GROVE CITY, OHIO - CITY COUNCIL Agenda

November 18, 2024

AN ORDINANCE TO ACCEPT THE PLAT OF HICKORY CREEK, SECTION 1

**RE: *Hickory Creek S1 Plat
Planning Commission Resubmittal
Review Comment Letter Responses***

PLAT

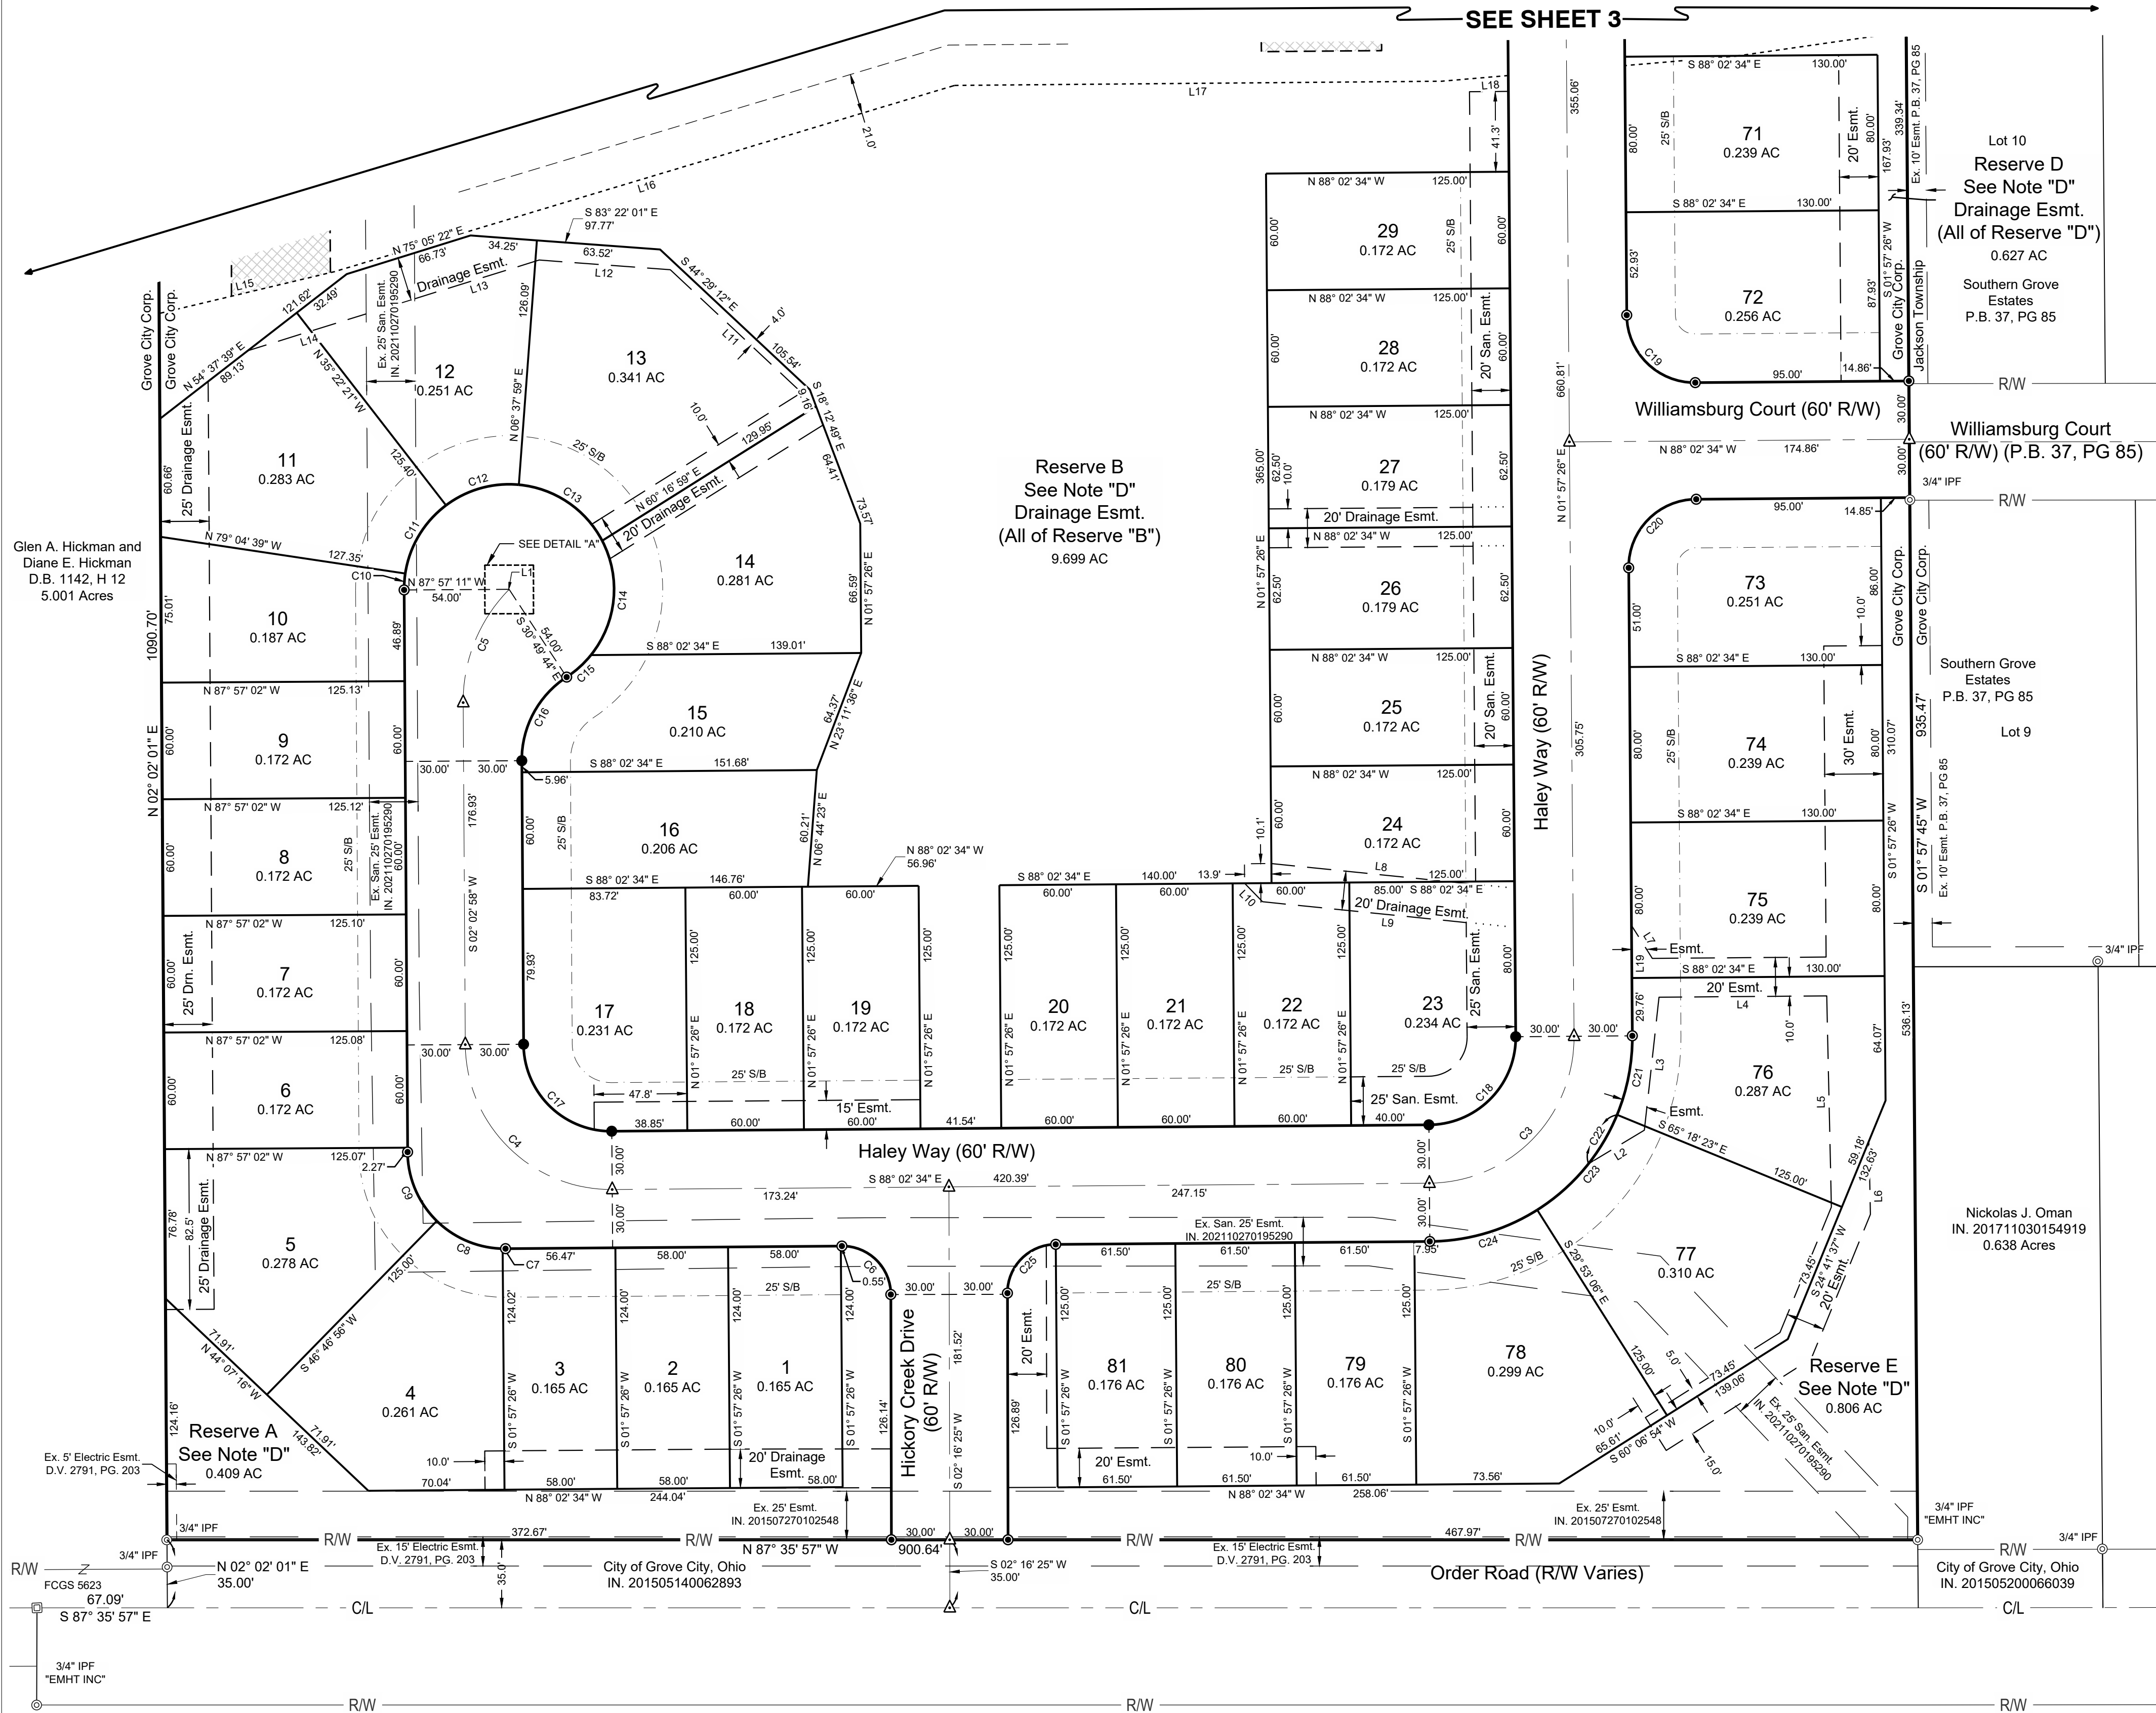
- **Comment:** Show width arrows and it should be "Ex. 25' Sanitary Easement"
Response: Width arrows and text revised.
- **Comment:** "Sanitary"
Response: Text revised.
- **Comment:** Include the easement line and width arrows
Response: Easement linework revised.
- **Comment:** "Electric"
Response: Easement label revised.
- **Comment:** This should be 25' and also include the lines for the width of the easement
Response: Easement linework shown and labeled accordingly.
- **Comment:** Bearing & Distance
Response: Revised accordingly.
- **Comment:** Mag set.
Response: Revised accordingly.
- **Comment:** Show entire 15' wide easement and include the word "Electric" in the label
Response: Easement in it's entirety is shown and label is revised.

- **Comment:** Label

- **Comment:** "Sanitary" and include width arrows

- **Comment:** Why are lot numbers not consecutive?

- **Comment:** Reserve C?

Response: Easement labeled.

Response: Easement label revised accordingly and width arrows added.

Response: The rest of the lot numbers are within Section 2 which is under a different cover.

Response: Reserve C is within Section 2 which is under a different cover.

C2.0

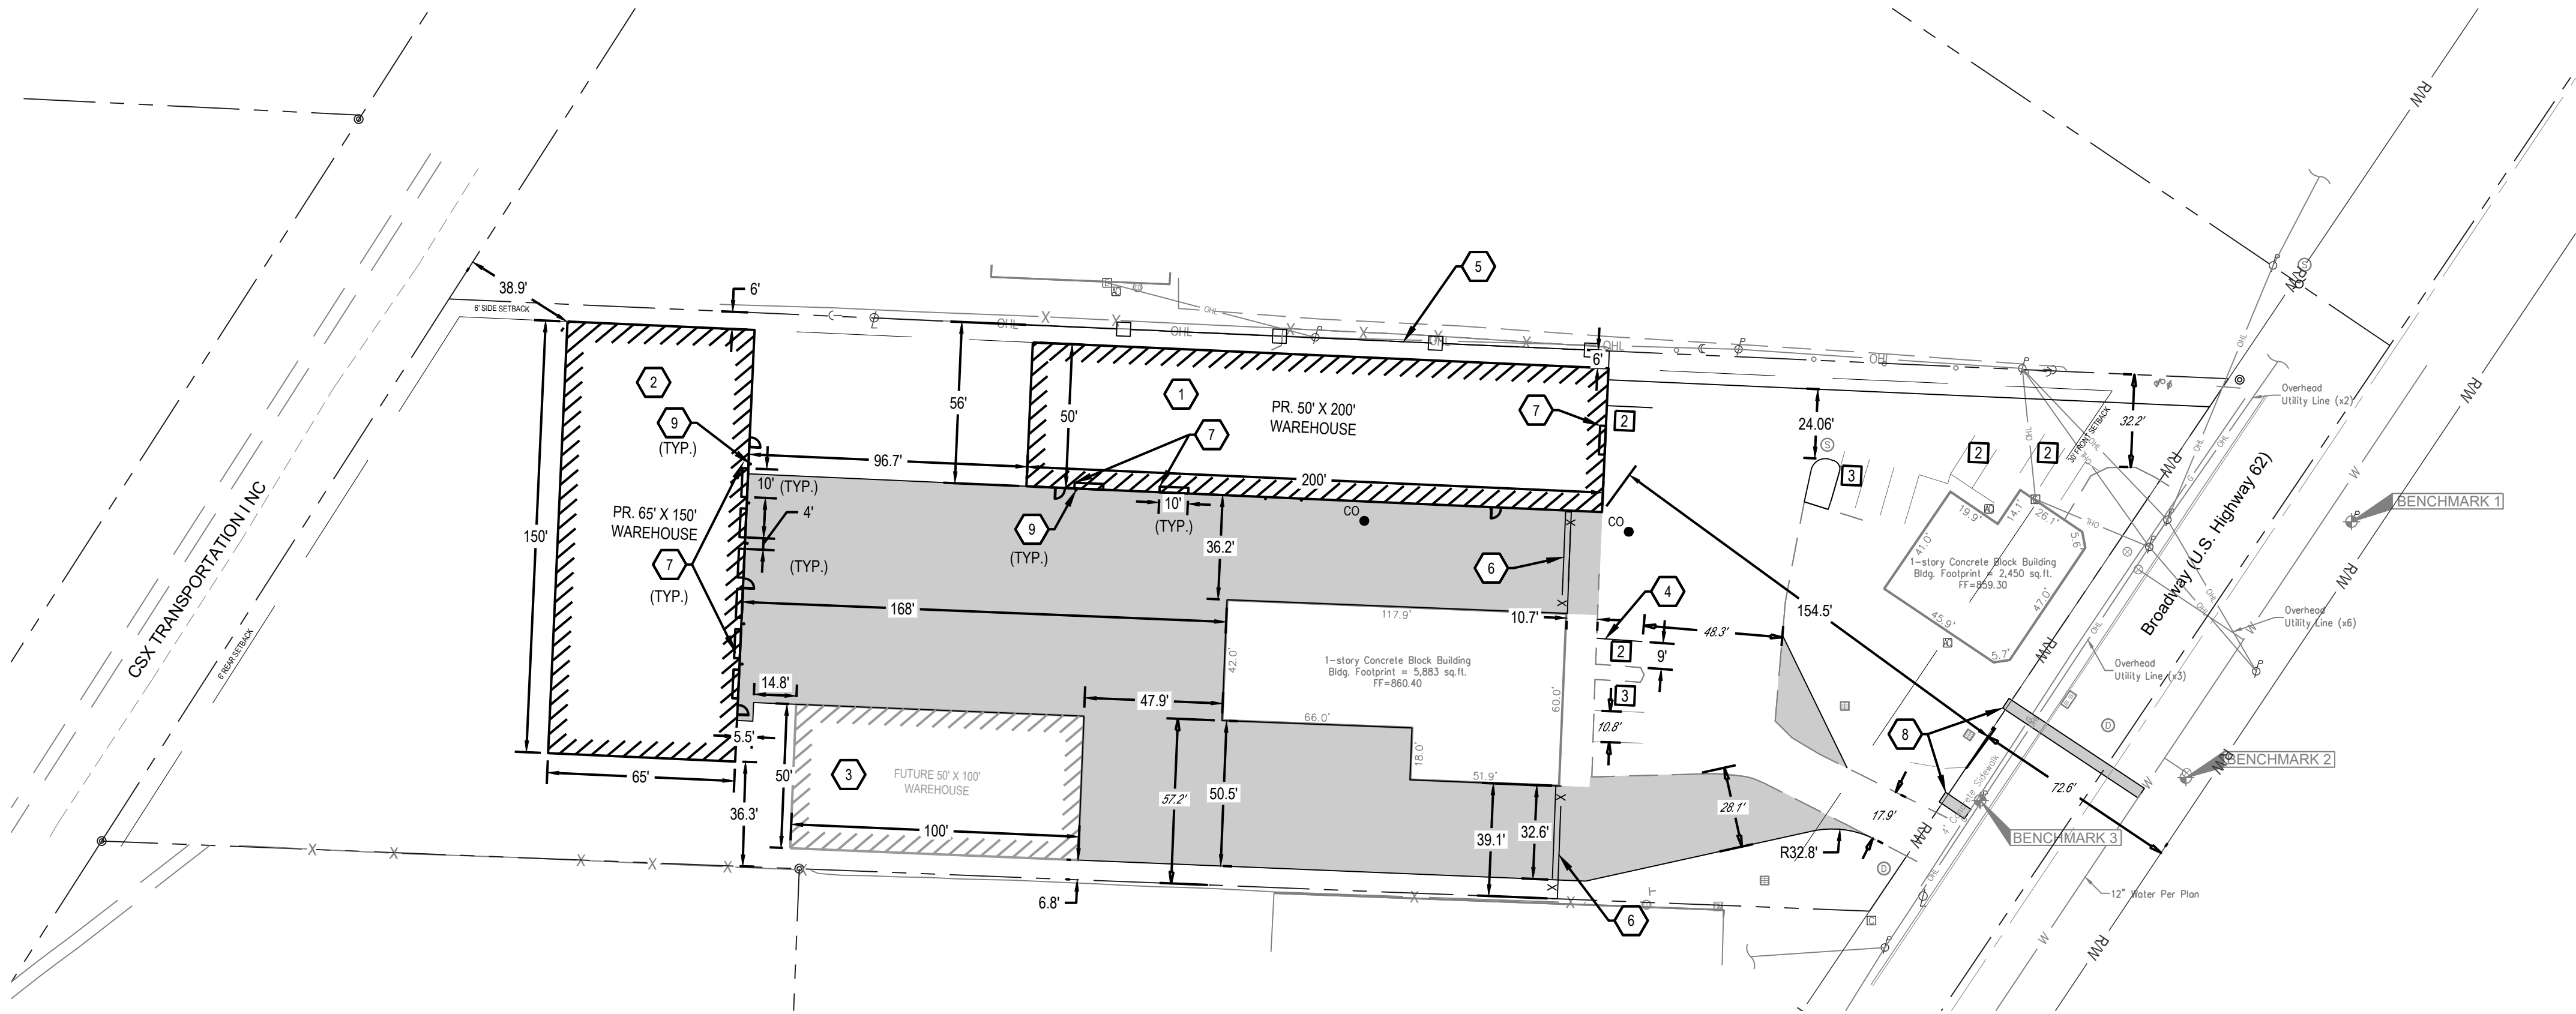
1. A deviation shall be granted from Section 1136.06(b) to reduce the required 20-foot-drive aisle setback by 13.5 feet for a total drive aisle setback of 6.5 feet and waive the landscape planting requirements along the southern property line.

4. Site lighting shall be added to the existing building and front parking area, meeting the 0.5 footcandle requirement outlined in the Code.
5. The two parking spaces closest to Broadway at the northernmost curb cut shall be removed to ensure safe site access.

6. A deviation shall be granted to reduce the required 10-foot parking setback along the north property line to minimize the impact on the Skate America parking lot, while still allowing adequate space for plantings.

Drawing Title:
PHOTOMETRIC PLAN

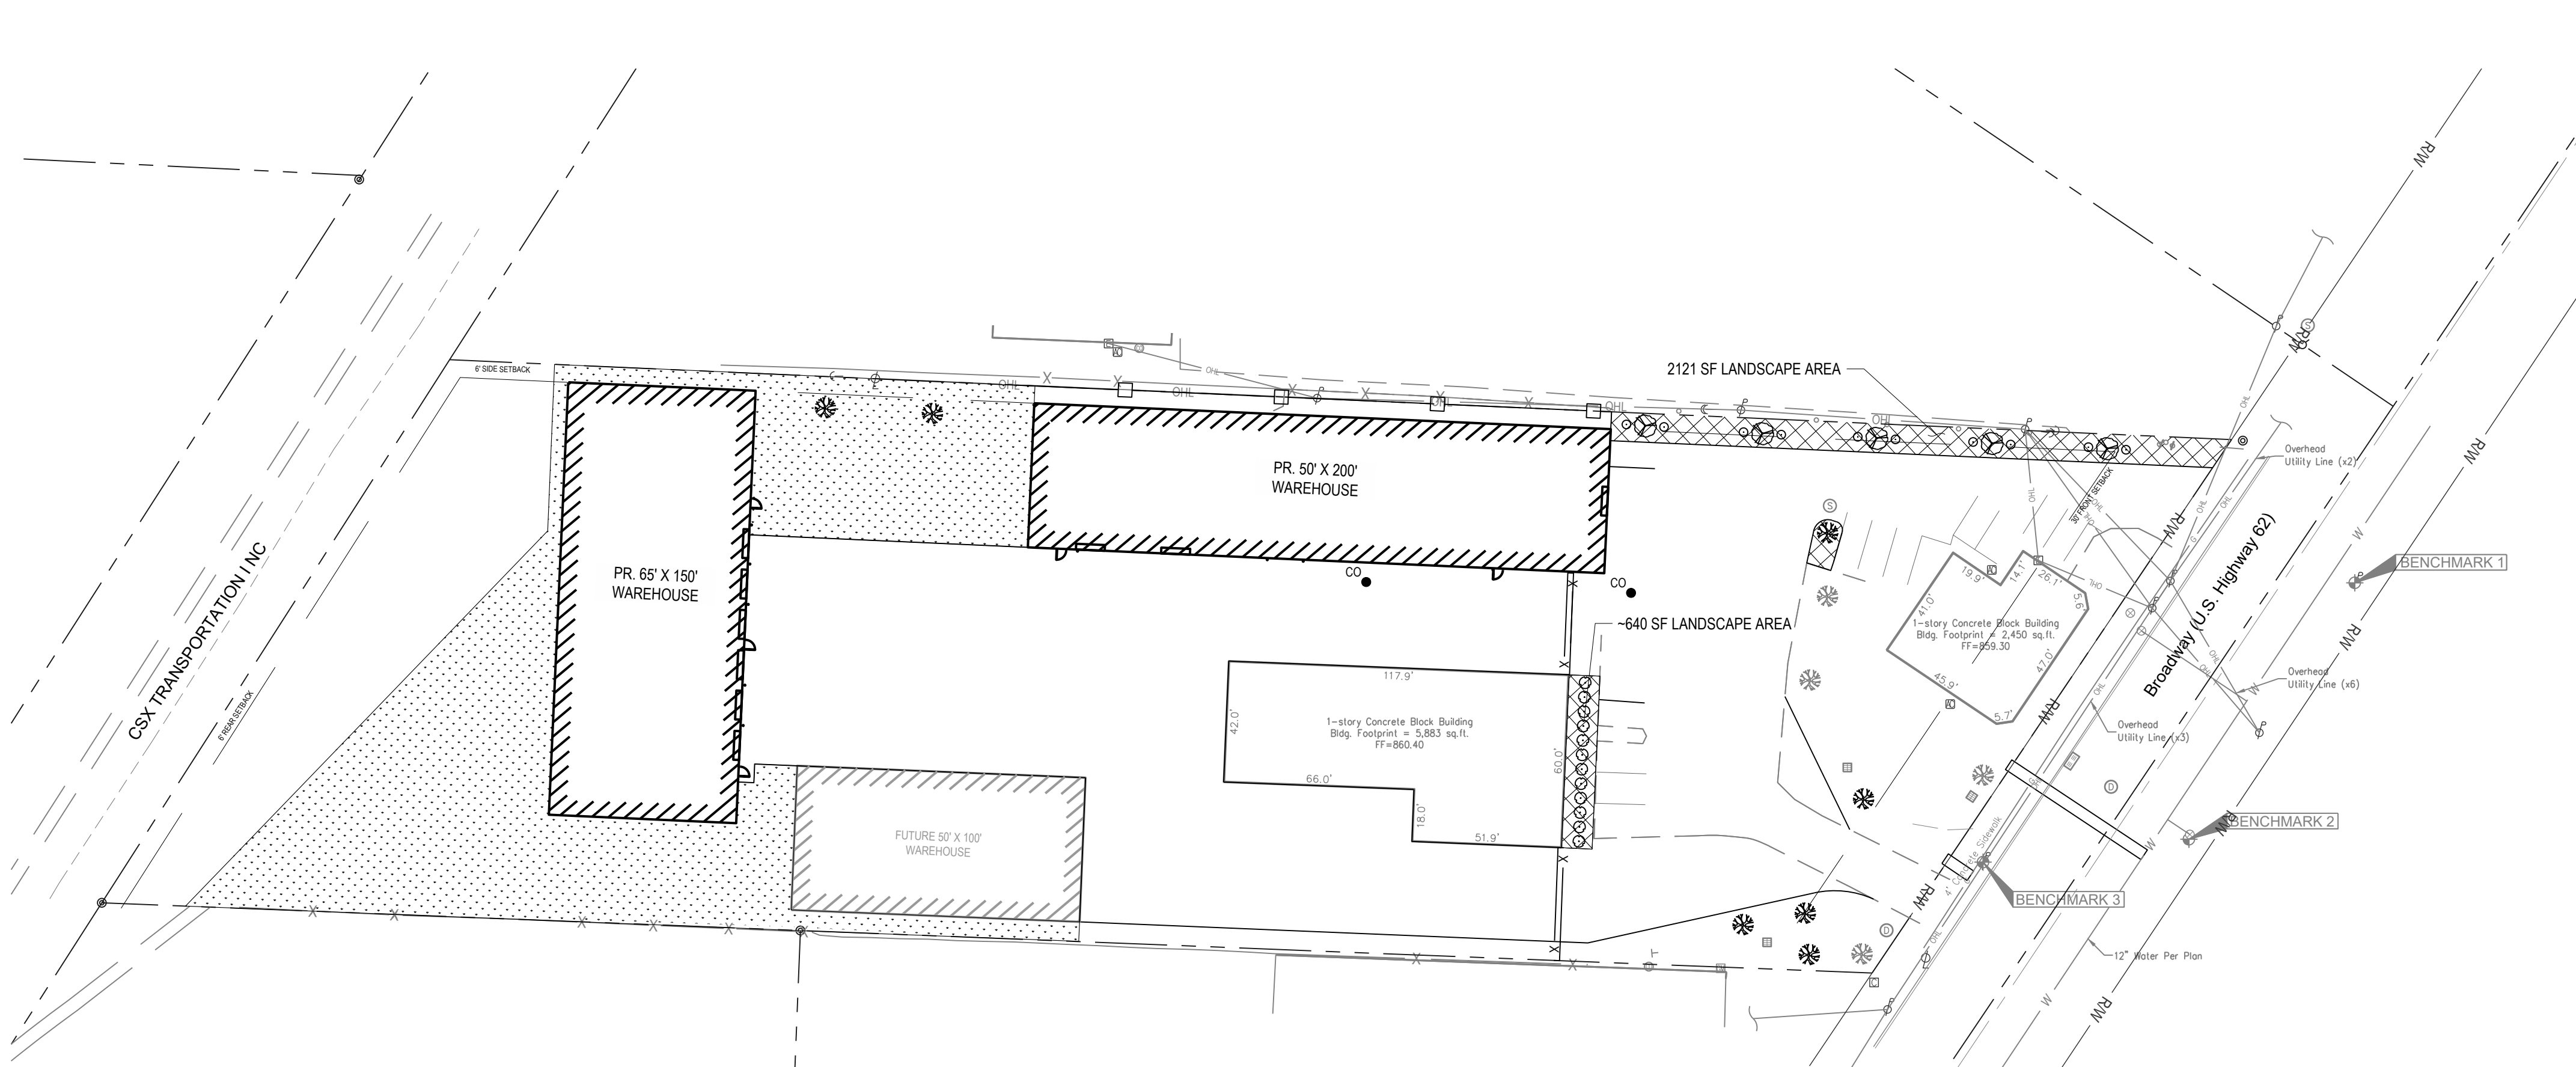
A photometric plan that meets the code requirement of 0.5 footcandles for the rear area around the proposed buildings was provided. Materials state that the site lighting will be downcast rectangular bronze LED wall pack fixtures. While the code requirement is met for the rear area, the front area currently has no proposed light fixtures. To meet code requirements, site lighting shall be added to the existing building and parking area along Broadway, meeting the 0.5 footcandle requirement for vehicular and pedestrian areas.

PAVEMENT AREAS UNDER THE 0.5 F.C. MINIMUM THRESHOLD WILL BE BROUGHT UP TO CODE REQUIREMENTS WHEN THE FUTURE WAREHOUSE BUILDING IS CONSTRUCTED. WALLPACKS WILL BE ADDED TO THE FUTURE BUILDING TO ENSURE ALL MINIMUM LIGHT LEVELS ARE MET TO MEET CITY CODE.
